DART AEROSPACE LTD.		- Work Order :	23882
Description: 204 Skid Tube 'I' Beam		Part Number:	D2597
Drawing Ref: D2597 Rev D		Qty:	3

WORK ORDER

DETAIL A
SCALE 5:24

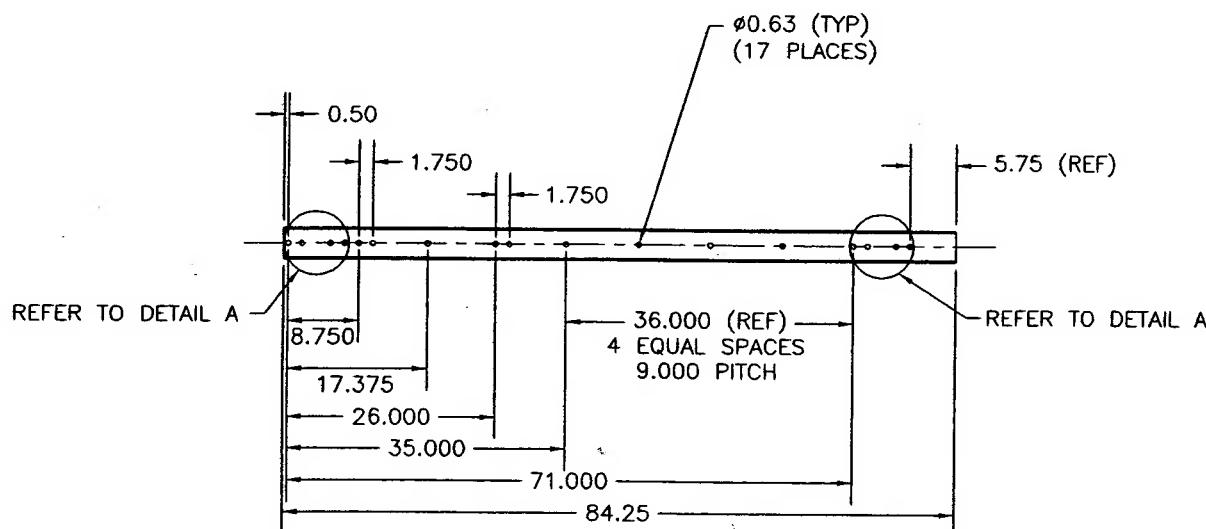
W/O:		WORK ORDER CHANGES					
DATE	STEP	PROCEDURE CHANGE	By	Date	Qty	Approval Mfg / Design Mgr	Approval QC Inspector
05-08-17	4	Alodine should be before the inspection to ensure Alodine i web is completed properly permanent change	John			John 05/08/17	2 05-08-17

NCR:		WORK ORDER NON-CONFORMANCE (NCR)						
DATE	STEP	Description of NC Section A	Corrective Action Section B			Verification Section C	Approval Design Mgr	Approval QC Inspector
			Initial Design Mgr	Action Description Design Mgr	Sign & Date			
05-08-11	2	Webs A $\frac{1}{16}$ too short, webs were cut on the line.	John 05/08/17	Acceptable this time. drill sig was centered to webs to compensate the $\frac{1}{16}$ difference	INC 05-08-11	John 05-08-11	John 05/08/17	2 05-08-11
